THE SERVICED GRID CODE – ISSUE 5 REVISION 17

THE GRID CODE – ISSUE 5 REVISION 17

GC0062 – Fault Ride Through

Figure 5a

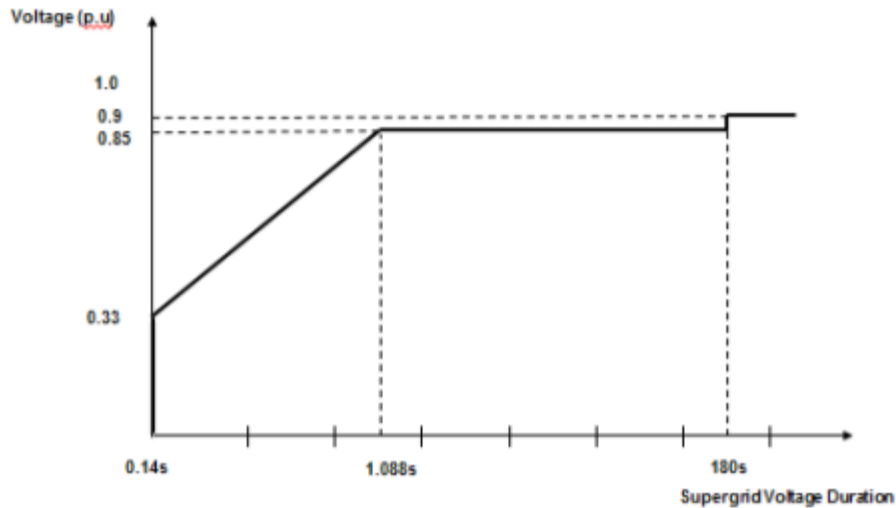
This proposal seeks to modify the Grid Code to provide clarity on the fault ride through requirements applicable to synchronous generating units. The proposals contain new provisions for these requirements which set a more achievable voltage duration characteristic against which compliance can be assessed. The new provisions do not materially affect the robustness and integrity of the transmission system.

- (i) remain transiently stable and connected to the **System** without tripping of any **Synchronous Generating Unit** for balanced **Supergrid Voltage** dips and associated durations on the **Onshore Transmission System** (which could be at the **Interface Point**) anywhere on or above the heavy black line shown in Figure 5a. Appendix 4A and Figures CC.A.4A.3.2 (a), (b) and (c) provide an explanation and illustrations of Figure 5a; and,

- (ii) provide **Active Power** output at the **Grid Entry Point**, during **Supergrid Voltage** dips on the **Onshore Transmission System** as described in Figure 5a, at least in proportion to the retained balanced voltage at the **Onshore Grid Entry Point** (for **Onshore Synchronous Generating Units**) or **Interface Point** (for **Offshore Synchronous Generating Units**) (or the retained balanced voltage at the **User System Entry Point** if **Embedded**) and shall generate maximum reactive current (where the voltage at the **Grid Entry Point** is outside the limits specified in CC.6.1.4) without exceeding the transient rating limits of the **Synchronous Generating Unit** and,

- (iii) restore **Active Power** output following **Supergrid Voltage** dips on the **Onshore Transmission System** as described in Figure 5a, within 1 second of restoration of the voltage to 1.0p.u of the nominal voltage at the:

Figure CC.A.4A3.1

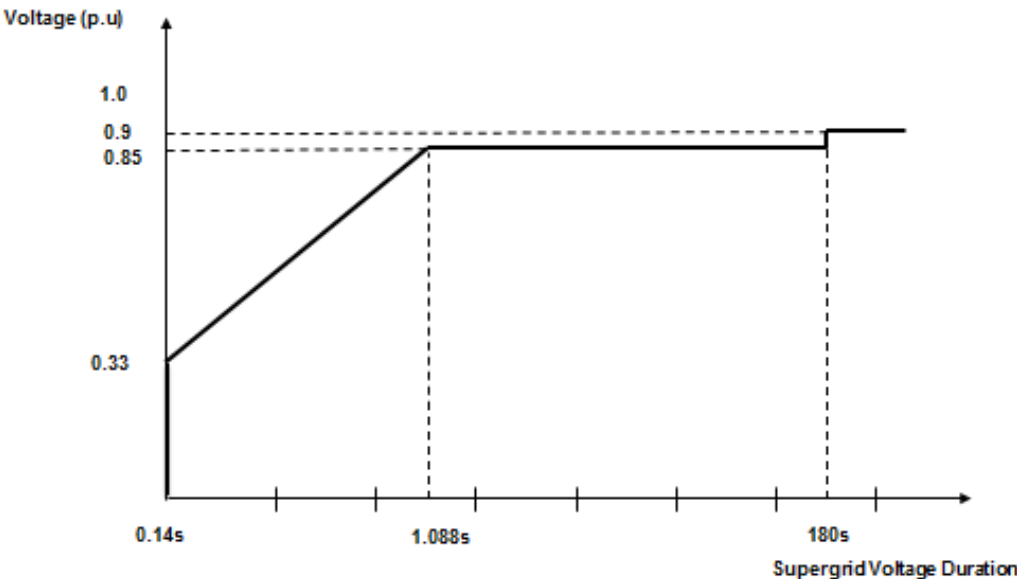
For balanced **Supergrid Voltage** dips on the **Onshore Transmission System** having durations greater than 140ms and up to 3 minutes, the fault ride through requirement is defined in CC.6.3.15.1 (1b) and Figure 5a which is reproduced in this Appendix as Figure CC.A.4A3.1 and termed the voltage–duration profile.
